New Folder Name Service Road Dimensions

LIGO-T950042-00-B

FROM:	Larry Jones
ORGANIZATION:	LIGO Project
FAX NUMBER:	(818) 304-9834
VOICE NUMBER:	(818) 395-2970
REFER TO:	
SUBJECT:	service road dimensions

Figure 1 -- Alternate 1 with Modified Compaction and Soil Stabilization

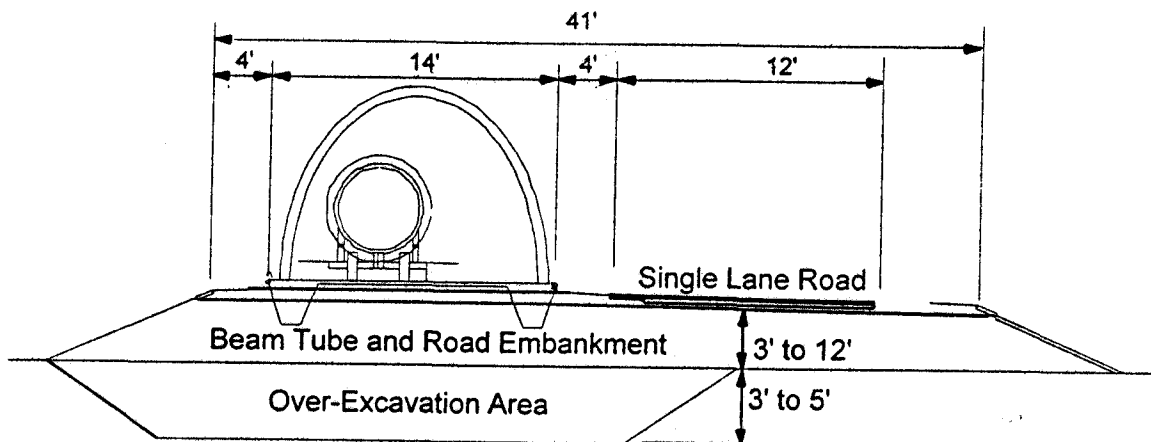
NOTE: Please comment on the workability of the latest proposed service road position on the attached sketch (Alternate 1). The 12' width represents pavement, which would not be in place during beam tube installation. The gravel base during beam tube installation reaches to the right, at the 41' dimension. This allows 23' from slab edge to berm edge. Is this acceptable?
